Reply to comments

[General Comment]

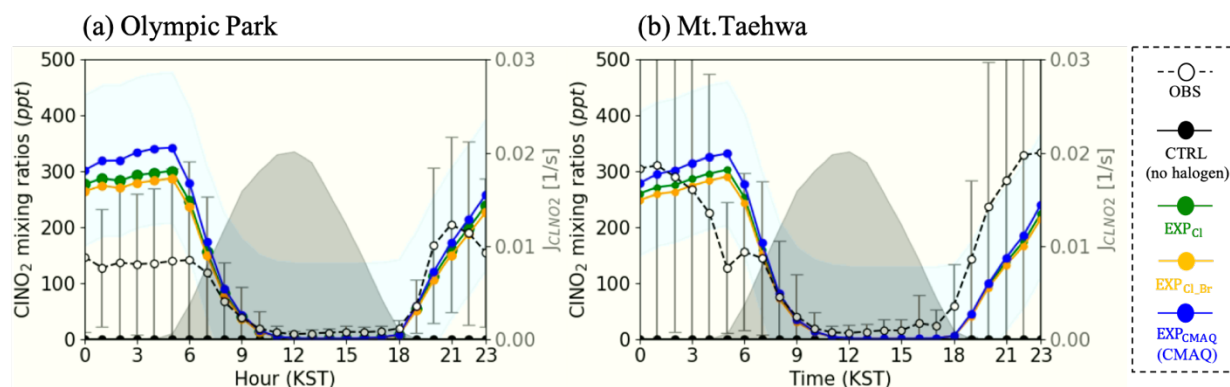
Comment 1: Regarding Reviewer1 Comment2: In section 3.1.1, there is an "...", the authors point to the EXP_cl and EXP_cl_br lines in Fig. R1, but I do not see those lines in the figure.

Reply: We apologize for the confusion caused by the inconsistent labelling. In Fig. R1, EXP_{Cl} and EXP_{Cl_Br} are shown as green and yellow lines, respectively, together with the results from CTRL, EXP_{CMAQ}, and observations. We revised the Fig. R1 to ensure that all labels are accurate and clearly correspond to the experimental cases.
